CITYWIDE PAVEMENT REPAIR AND REHABILITATION PROGRAM PHASE 2 2025
CIP 2025-05

ADDENDUM NO. 1

EXHIBIT M -ADDENDUM NO.1
CRACKFILL MAP

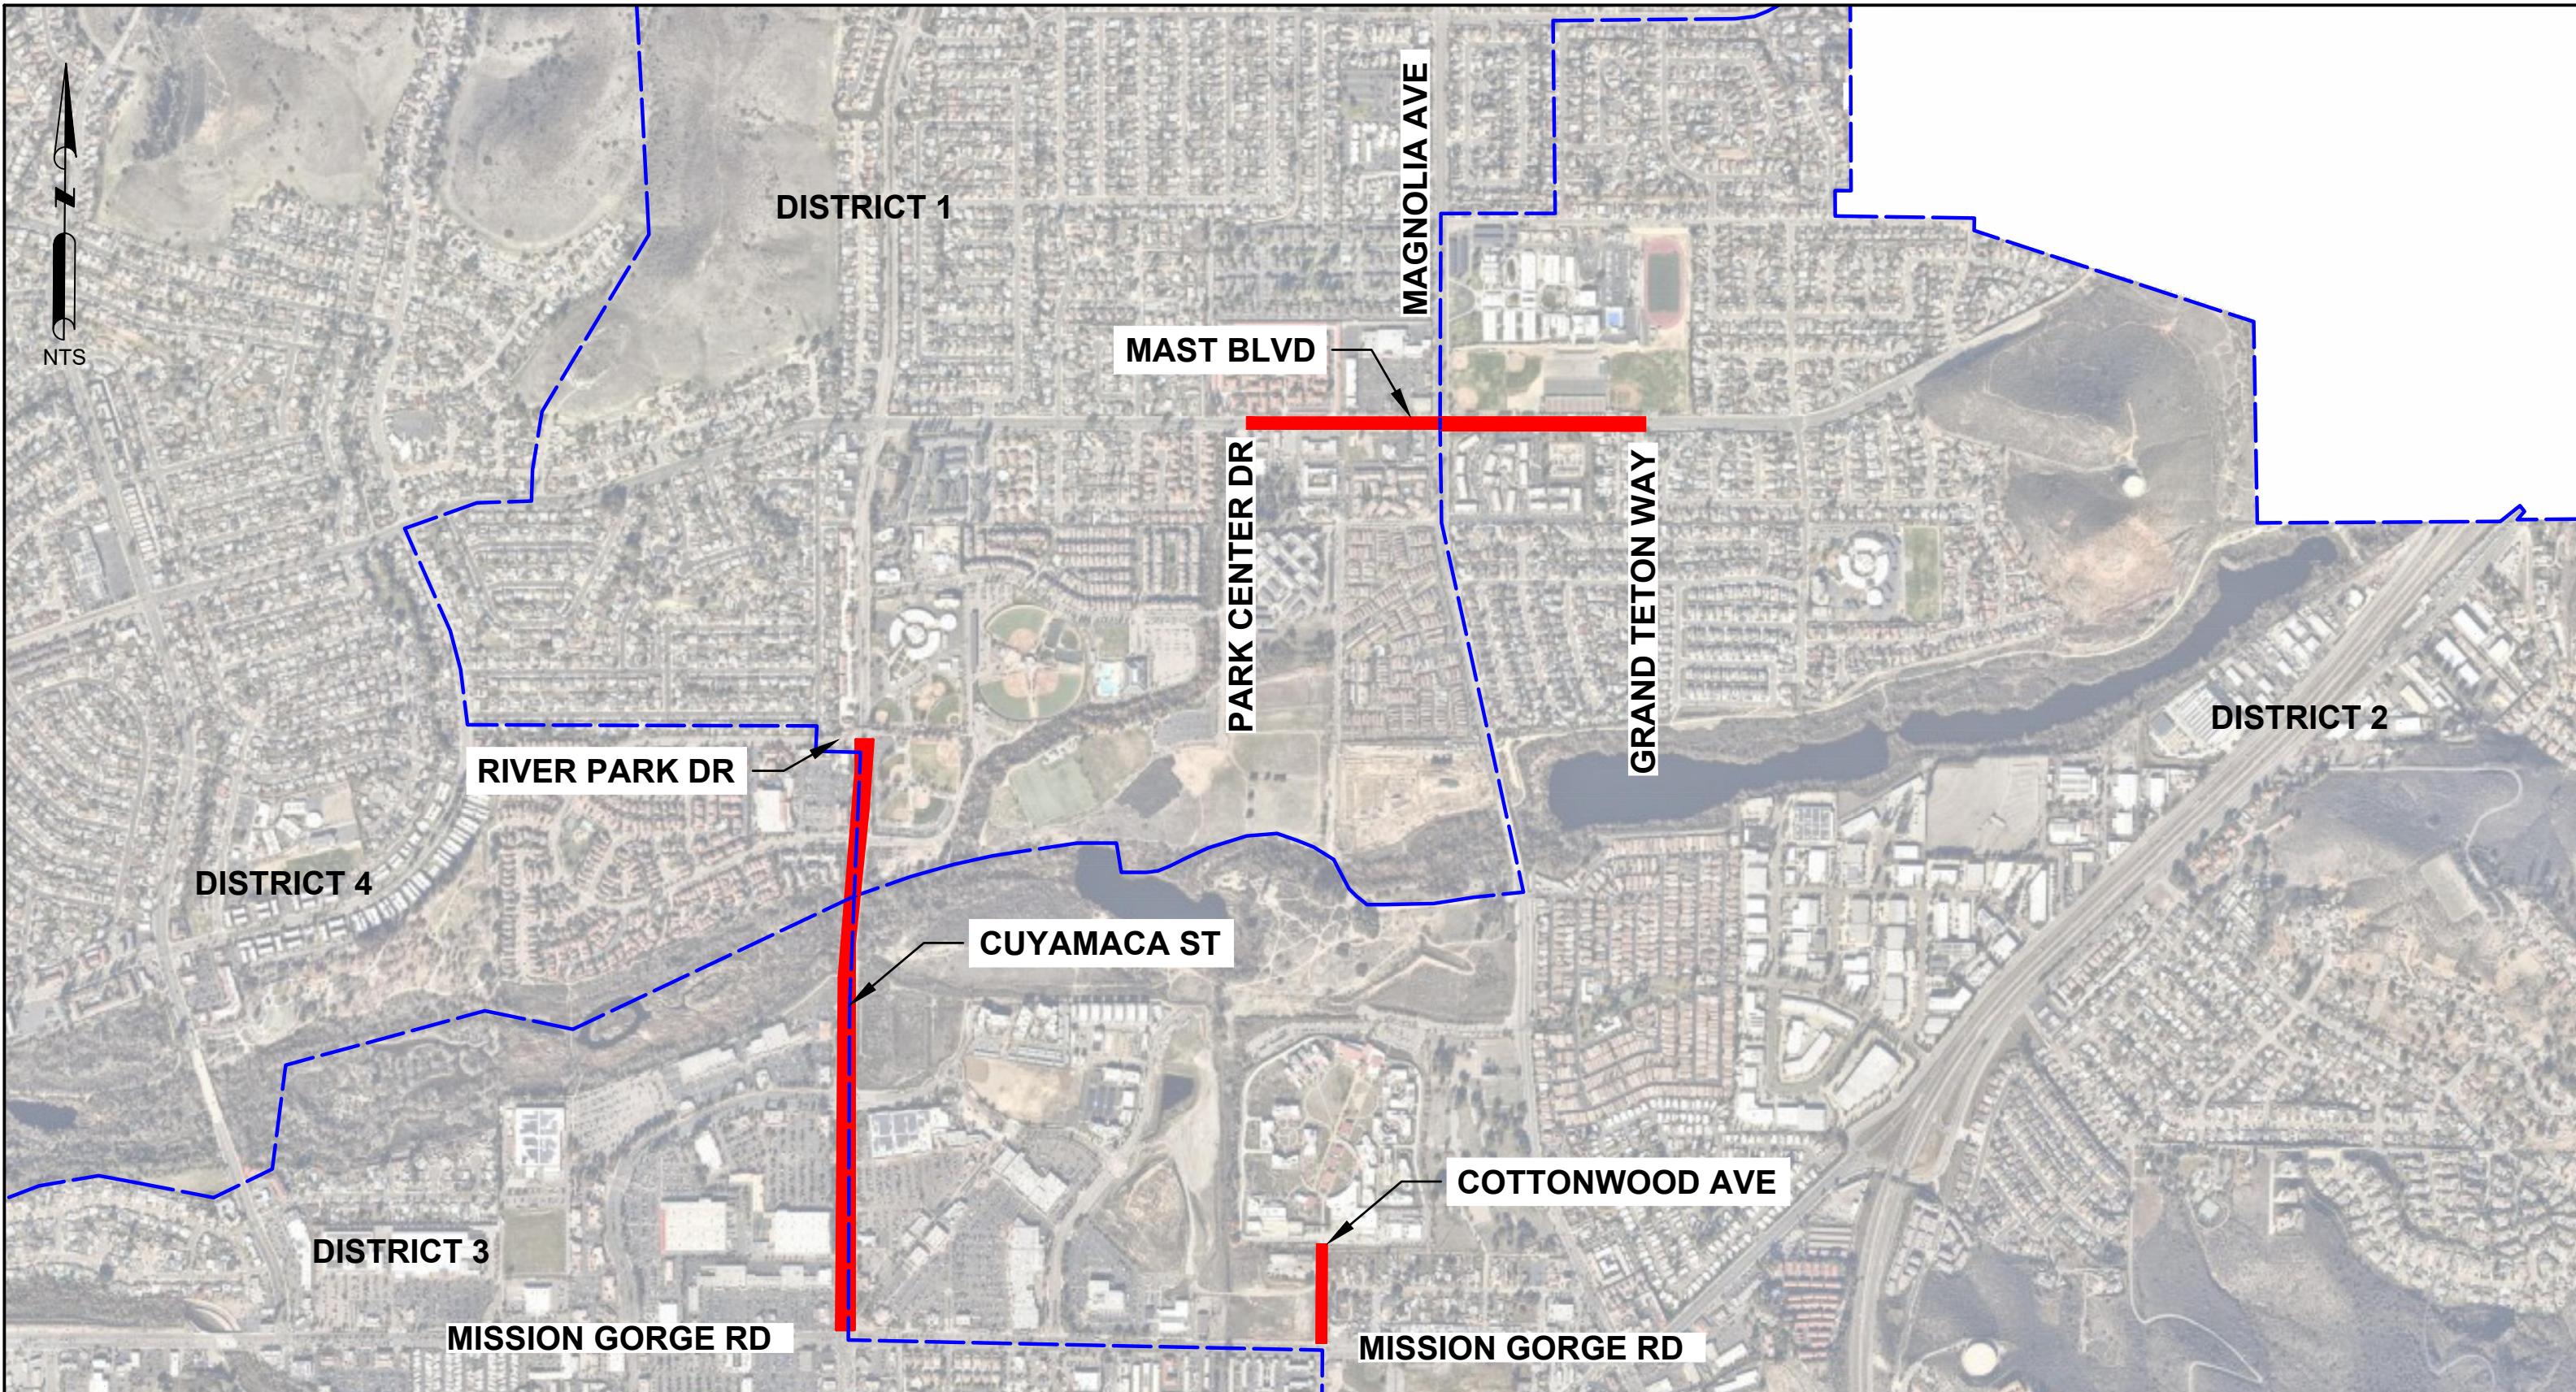
Replace Exhibit M with the attached **Exhibit M – Addendum No. 1**
